ATB-20/531-
21.86/22.11
PART 3

SIGNALIZED CLOSURE PLAN (ATB-531-22.11 EB LANE)

DESIGN AGENCY ODOT --- DISTRICT 4 PLANNING & ENGINEERING	DATE MM/DD/YY MJA	REVIEWED MJA STRUCTURE FILE NUMBER 0406813	DRAWN CMR REVISIONS CMR	DESIGNED CMR CHECKED MJA
STRUCTURE GENERAL NOTES ATB-531-2211 OVER CONNEAUT CREEK				
ATB-20/531-21.86/22.11 PART 3 PID No. 98903				
4 / 15				
24 36

TYPICAL SECTION 1

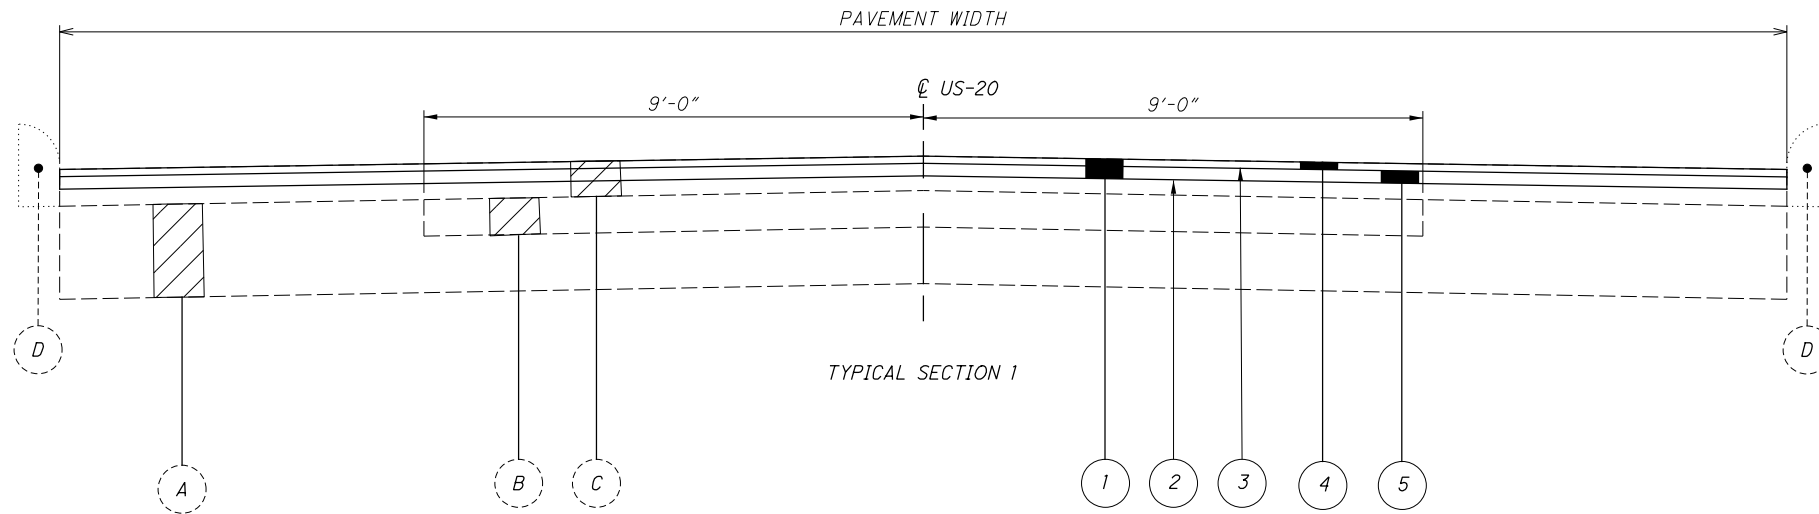
UPDATED

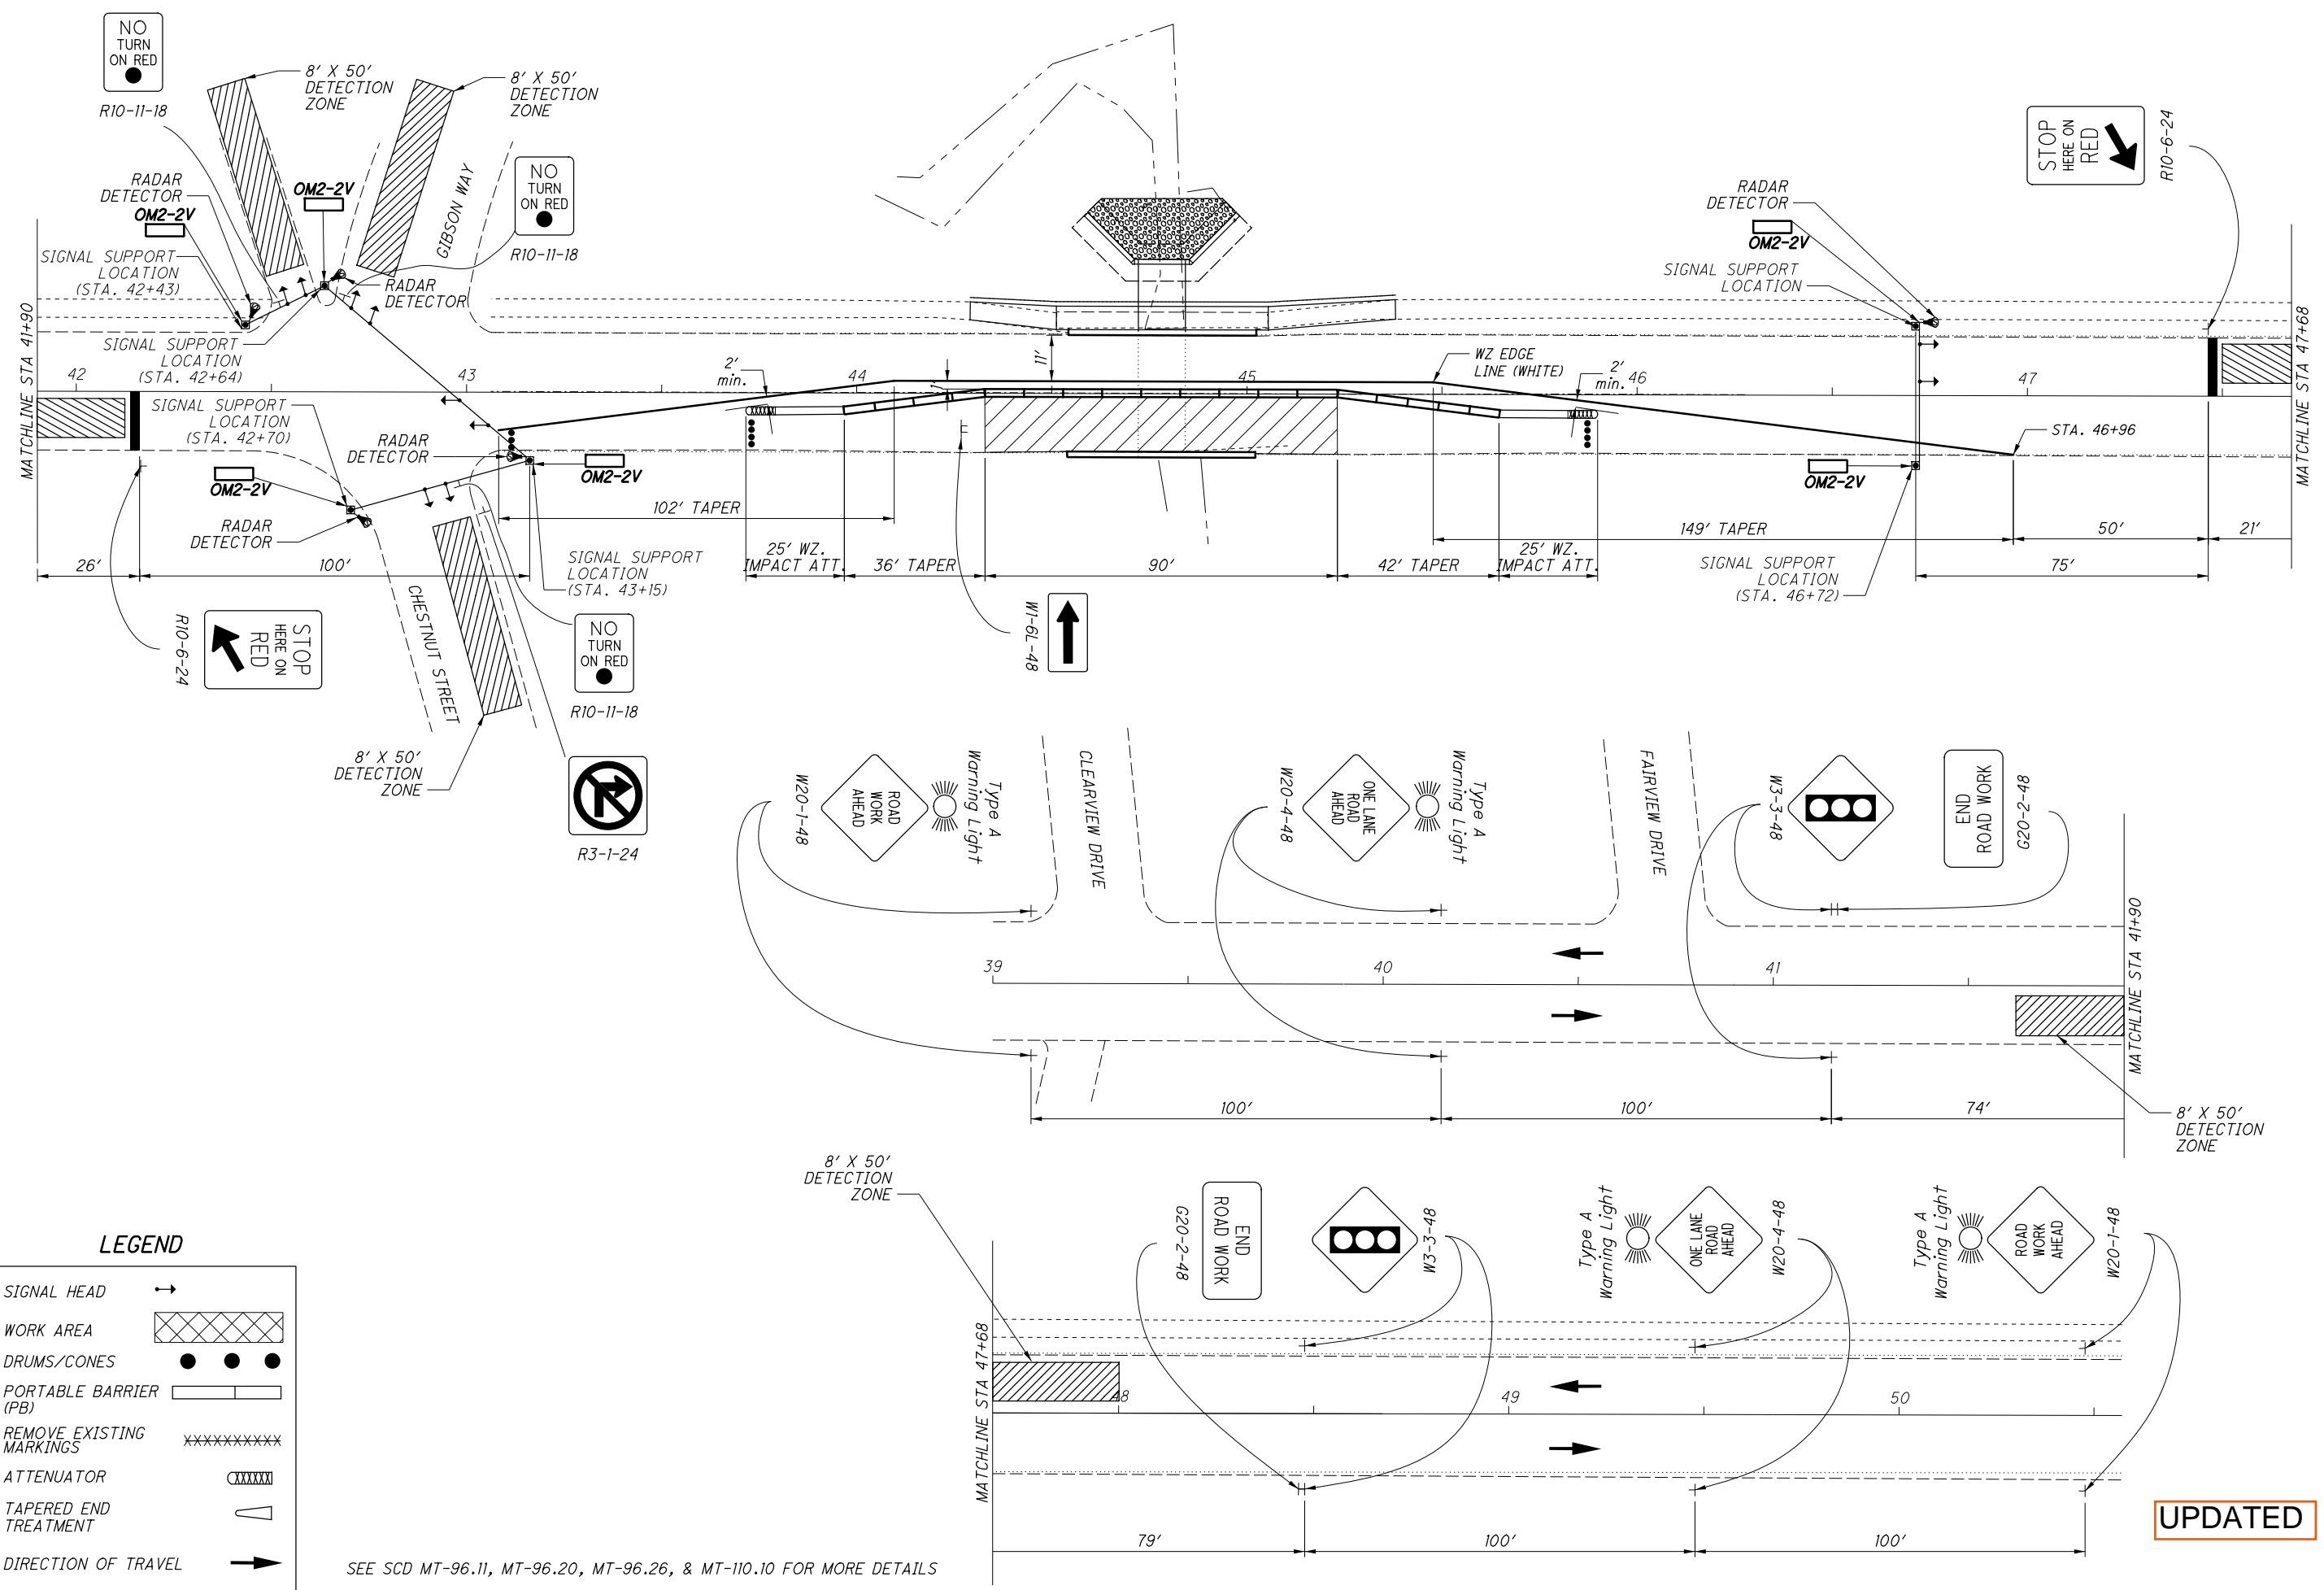
UPDATED

SIGNALIZED CLOSURE PLAN (ATB-531-22.11 WB LANE)

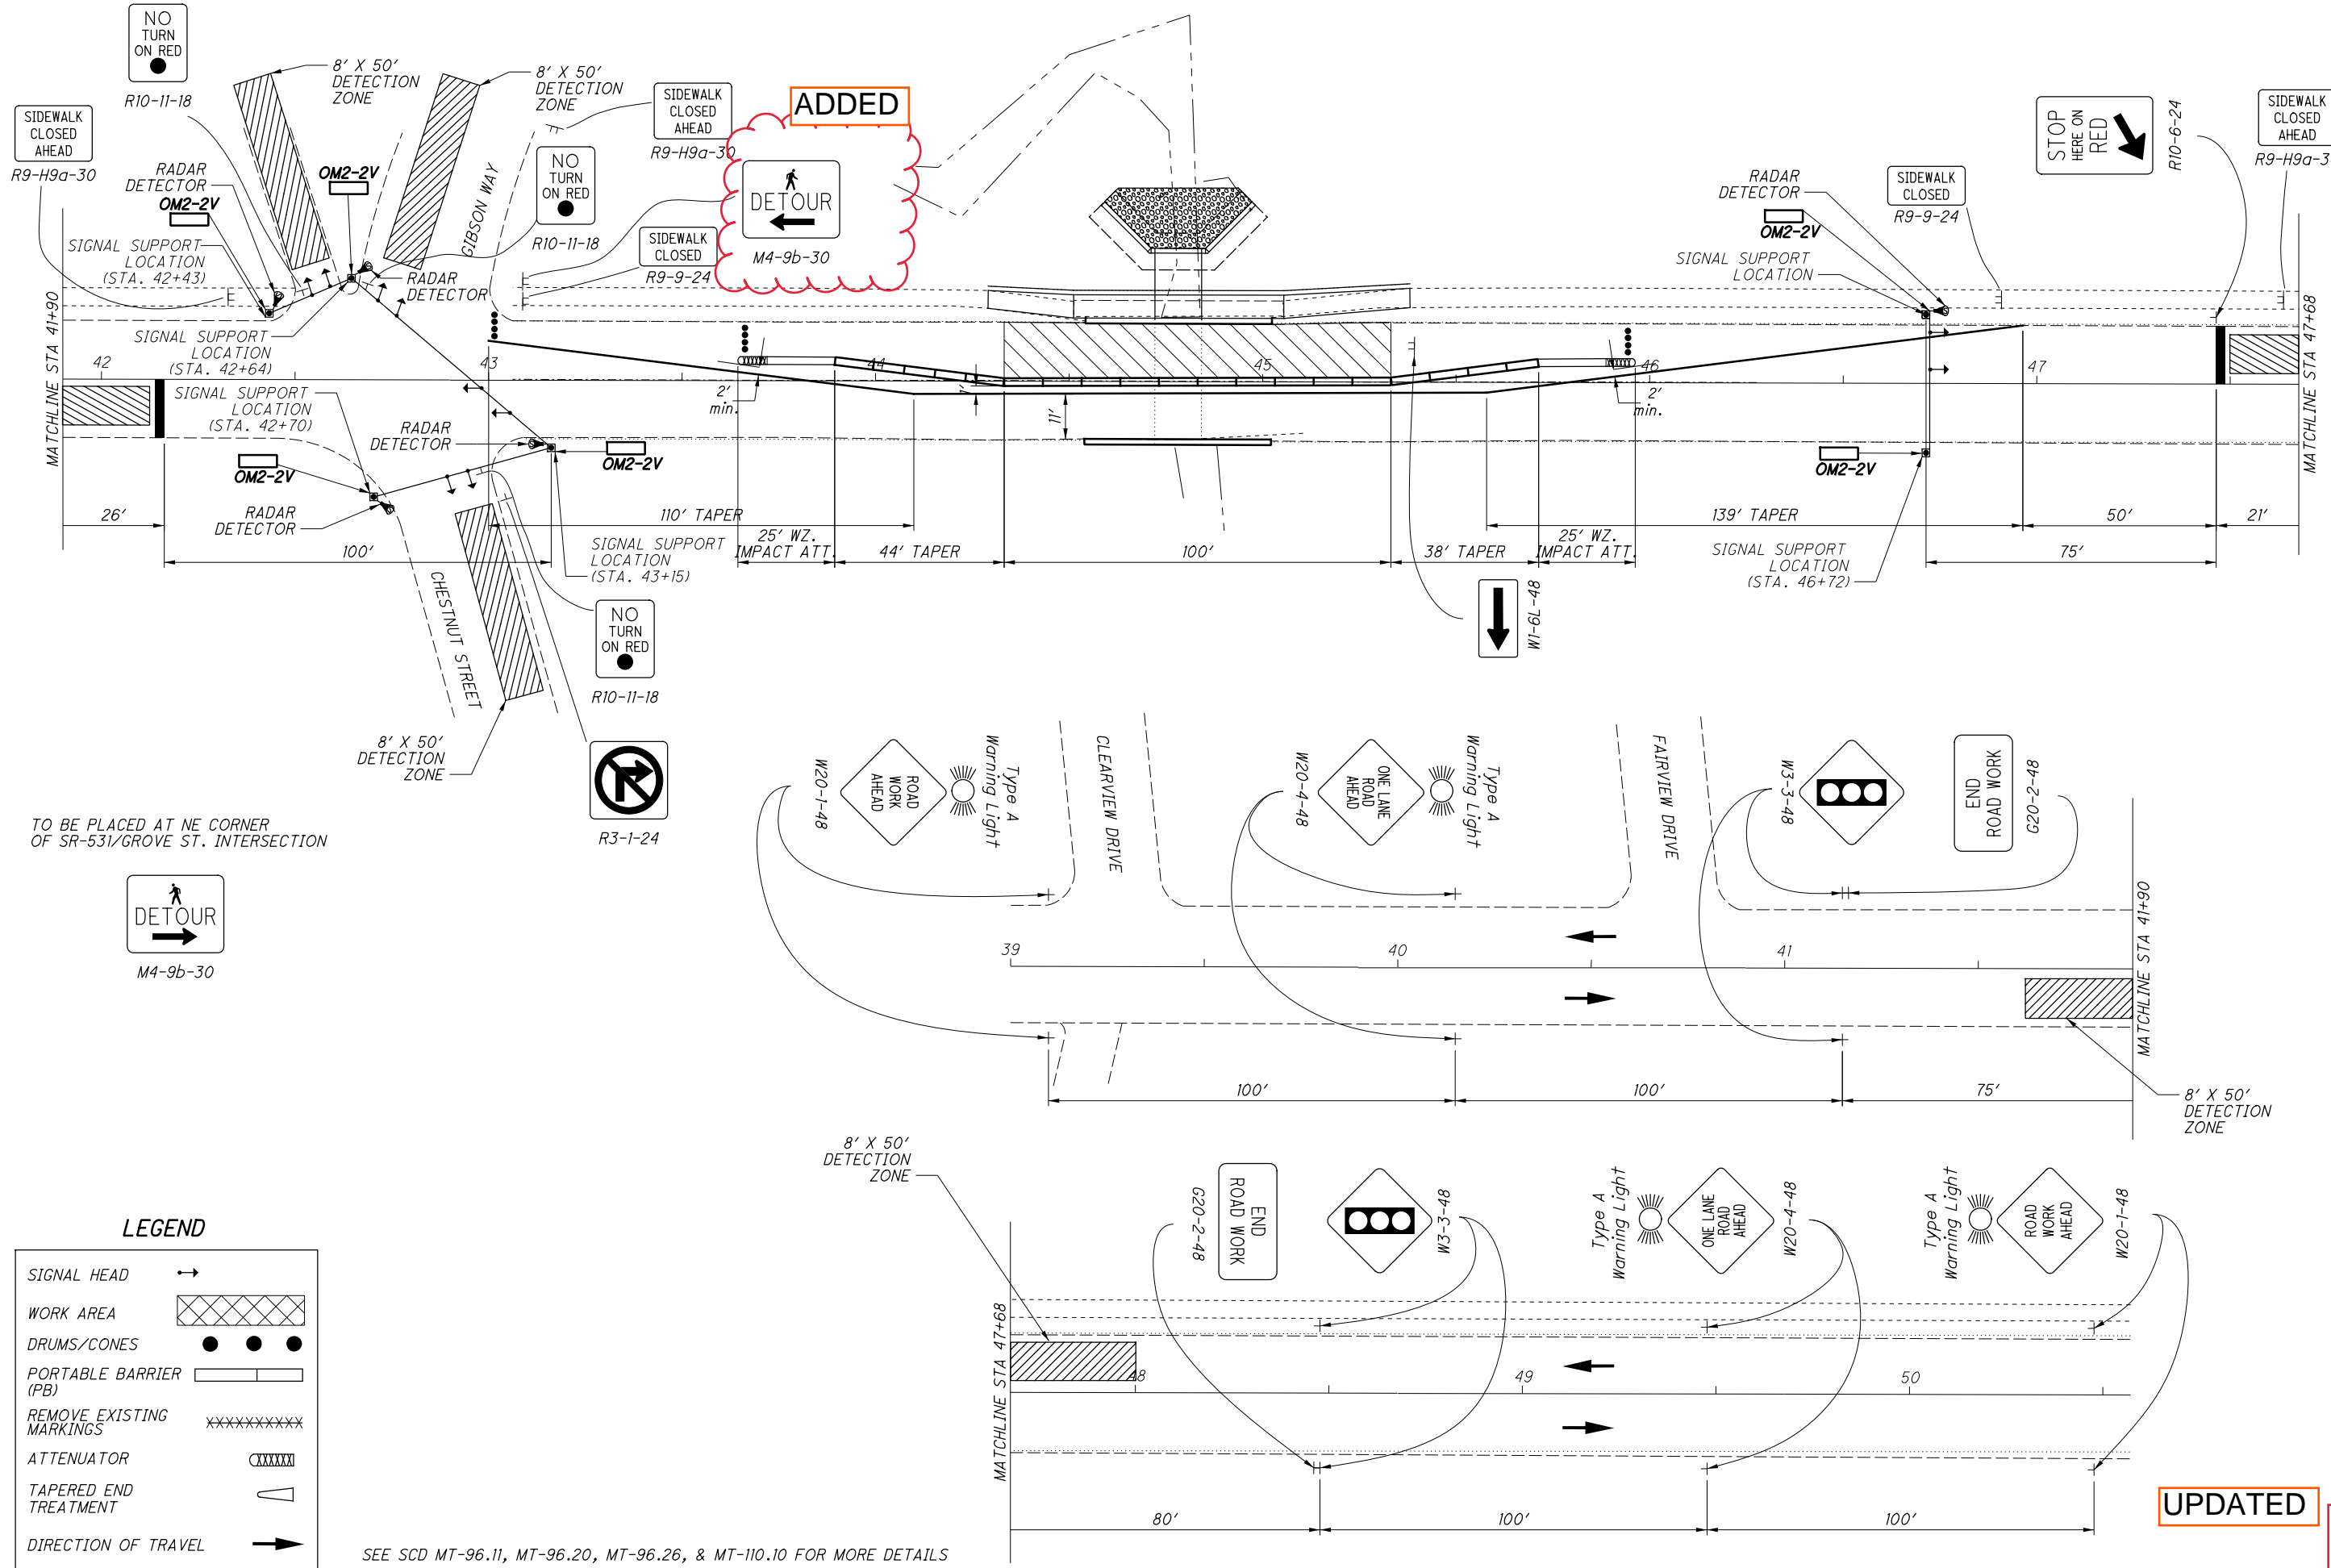
UPDATED

DETOUR PLAN FOR STRUCTURE: ATB-531-2211

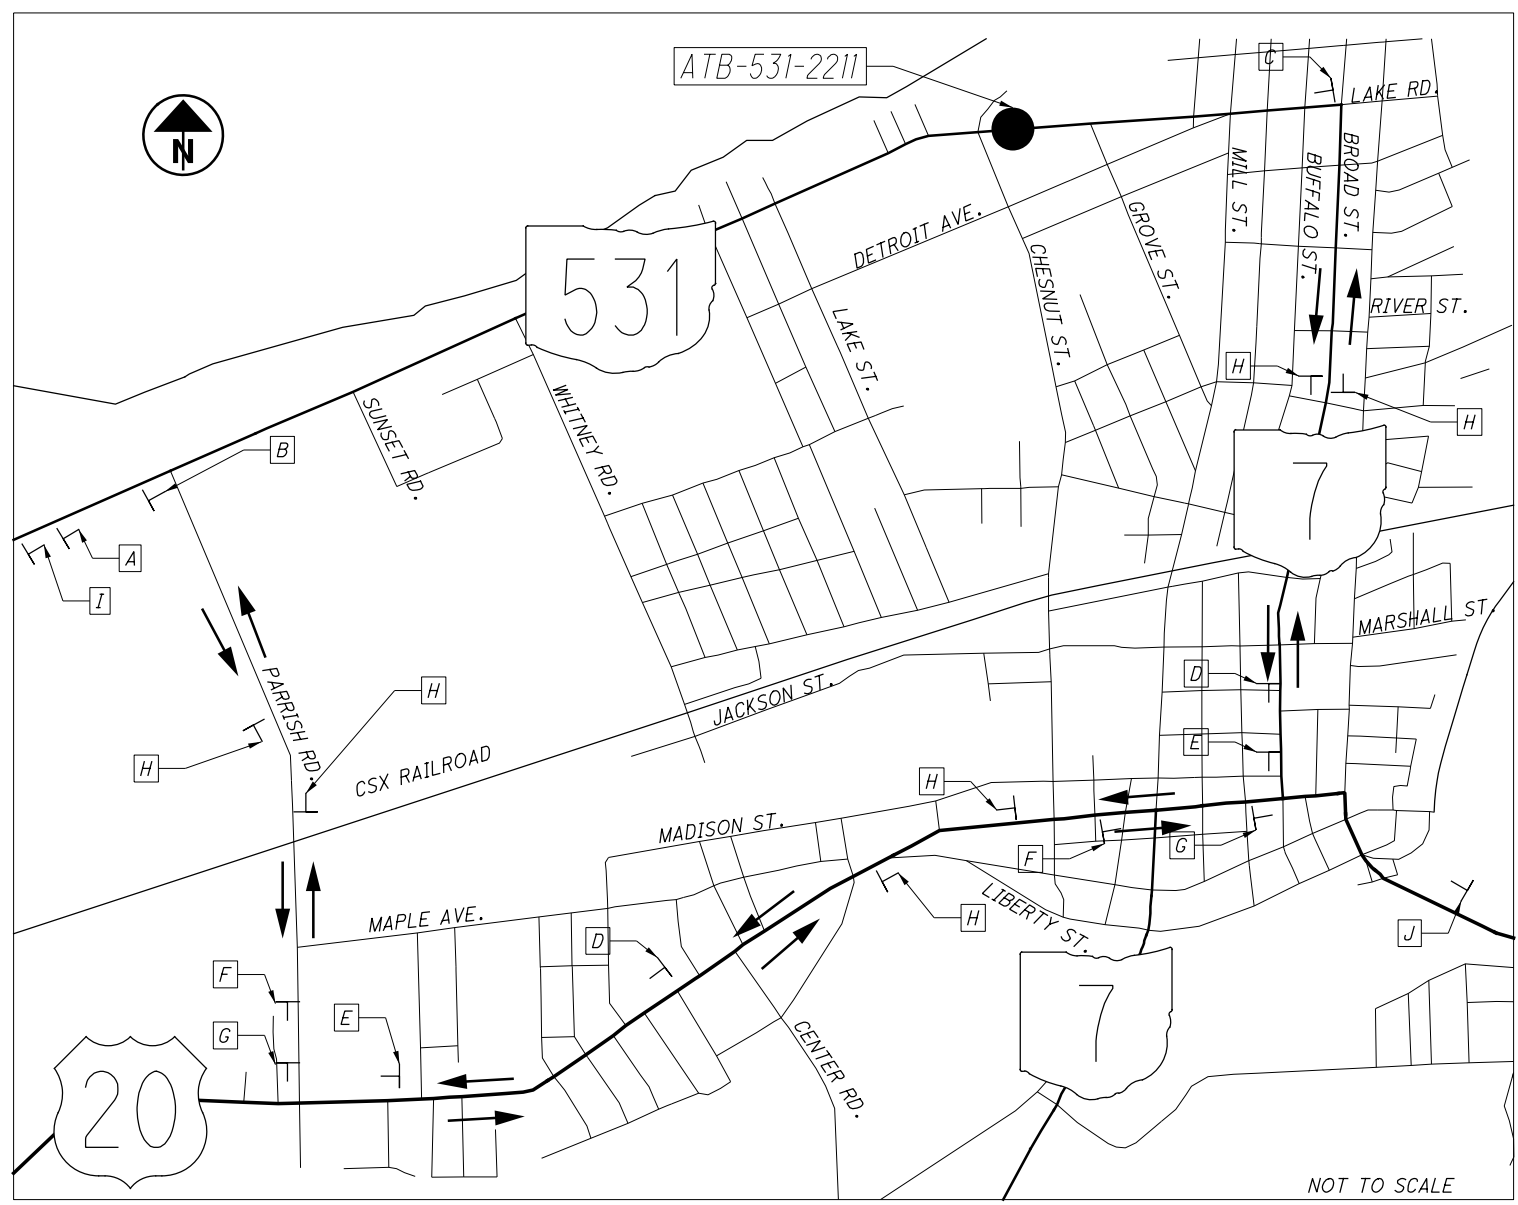
<p>A</p> <p>TRUCK M4-4-24</p> <p>DETOUR 1500 FT W20-2-36</p>	<p>D</p> <p>TRUCK M4-4-24</p> <p>DETOUR M4-8-24</p> <p>ADDED MI-4-24-3</p> <p> M5-1-21</p>	<p>G</p> <p>TRUCK M4-4-24</p> <p>DETOUR M4-8-24</p> <p>ADDED MI-4-24-3</p> <p> M6-1-21</p>
<p>B</p> <p>TRUCK M4-4-24</p> <p>ROAD CLOSED TO THRU TRAFFIC R11-4-60</p> <p>DETOUR M4-10R-48</p>	<p>E</p> <p>TRUCK M4-4-24</p> <p>DETOUR M4-8-24</p> <p>ADDED MI-4-24-3</p> <p> M6-1-21</p>	<p>H</p> <p>TRUCK M4-4-24</p> <p>DETOUR M4-8-24</p> <p>ADDED MI-4-24-3</p> <p> M6-3-21</p>
<p>C</p> <p>TRUCK M4-4-24</p> <p>ROAD CLOSED TO THRU TRAFFIC R11-4-60</p> <p>DETOUR M4-10L-48</p>	<p>F</p> <p>TRUCK M4-4-24</p> <p>DETOUR M4-8-24</p> <p>ADDED MI-4-24-3</p> <p> M5-1-21</p>	<p>I</p> <p>PORTABLE CHANGEABLE MESSAGE SIGN MESSAGES:</p> <ol style="list-style-type: none"> TRUCKS USE PARRISH RD TO US 20 E TO RT 7 N
		<p>J</p> <p>PORTABLE CHANGEABLE MESSAGE SIGN MESSAGES:</p> <ol style="list-style-type: none"> RT 531 CLOSED TO TRUCKS TRUCKS USE US 20 W TO PARRISH RD

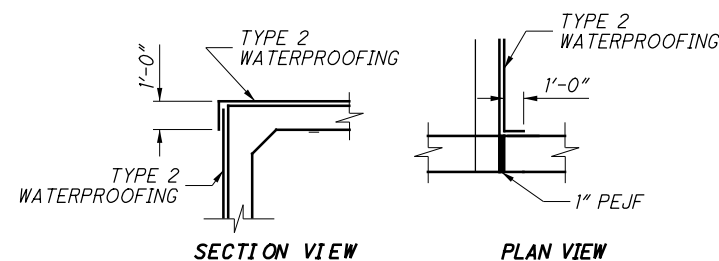
ADDED

IF PAVEMENT IS NOT PLACED DIRECTLY ON TOP OF THE CULVERT, TYPE 2 WATERPROOFING, PER CMS 512.08 AND 711.25 SHALL BE APPLIED TO THE ENTIRE TOP SURFACE OF THE PRECAST CULVERT SECTIONS (INCLUDING CAST-IN-PLACE SECTION) AND SHALL EXTEND ONE FOOT VERTICALLY DOWN THE SIDES FOR ALL PORTIONS OF THE CULVERT WHICH SHALL BE IN CONTACT WITH THE BACKFILL. PAYMENT FOR THE MEMBRANE WATERPROOFING SHALL BE AT THE CONTRACT PRICE BID PER SQUARE YARD FOR ITEM 512, TYPE 2 WATERPROOFING.
